Well Name: SAKER 6-7 FEDERAL COM	Well Location: T24S / R35E / SEC 6 / LOT 4 / 32.25326 / -103.412769	County or Parish/State: LEA / NM
Well Number: 24H	Type of Well: OIL WELL	Allottee or Tribe Name:
Lease Number: NMNM014164	Unit or CA Name:	Unit or CA Number:
US Well Number: 3002549464	Operator: OXY USA INCORPORATED

Notice of Intent

Type of Submission: Notice of Intent	Type of Action: APD Change
Date Sundry Submitted: 02/12/2025	Time Sundry Submitted: 02:34
Date proposed operation will begin: 07/15/2025

OXY USA INC., respectfully requests to amend the subject AAPD by revising the Well Name, SHL, BHL, TVD & Drill Plan as follows:

Property Name SAKER 6_7 FED	Well Number 24H	Drawn By R.J. 12-20-19	Revised By REV. 1 Z.T. 10-09-24 (SHL, WELLBORE AND FORMAT CHANGES)
--------------------------------	--------------------	---------------------------	---

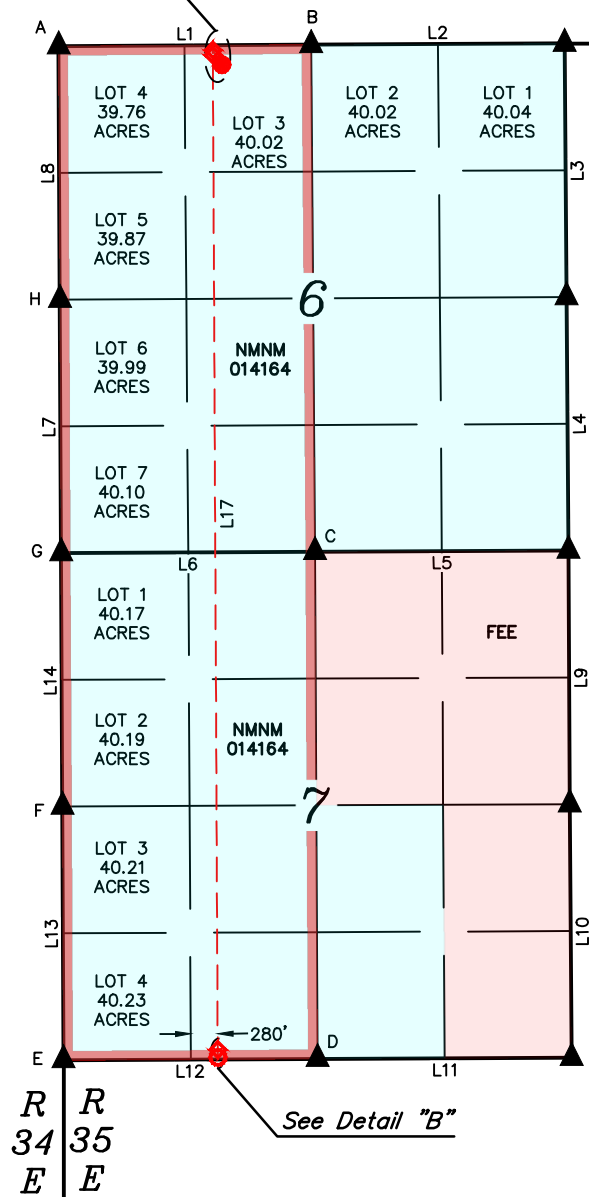
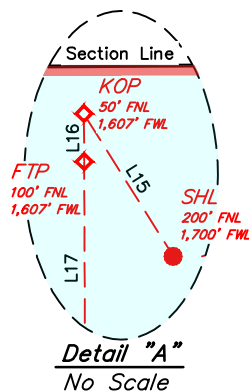
Old Well Name: SAKER 6_7 FEDERAL COM 24H
New Well Name: SAKER 6_7 FEDERAL 24H

Old SHL: 200' FNL 750' FWL
New SHL: 200' FNL 1700' FWL

Old BHL: 20' FSL 1657' FWL
New BHL: 20' FSL 1607' FWL

Old TVD: 10761'

New TVD: 10715'
